## Design Review Checklist for Woodbury Crossing lot 107

Master Plan Design Compliance Checklist:  
Prepared by Nicole Floyd for the 1/14/2021 DRB Meeting

**FIGURE 5A-11**

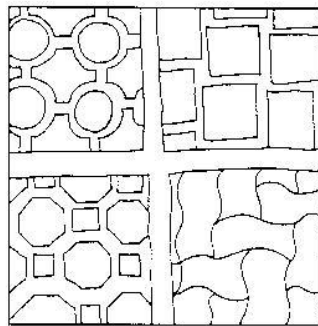
**Staff Comment:** Plans do not show the changes in pavement materials within pedestrian areas and at intersections. If the Board finds material changes to be appropriate, a condition approval is warranted. Staff has prepared a condition of approval that includes this requirement for the Board's review.

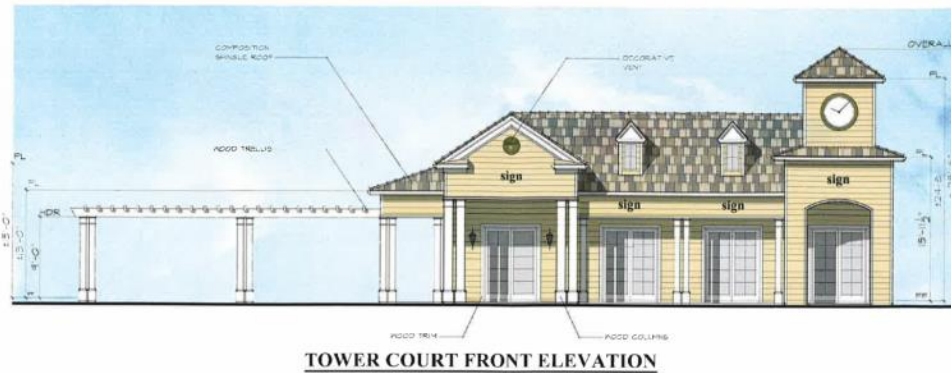
Staff Response: The proposal is generally consistent with the requirement. Emphasis has been placed on building orientation towards the Village Green, however the accessory parking lot serving four cars seems inconsistent with the intent to promote pedestrian orientation. As the project exceeds parking

requirements, the additional parking lot should be removed and replaced with the enhancements to the Village Green as shown in illustrative imagery from the Master Plan.
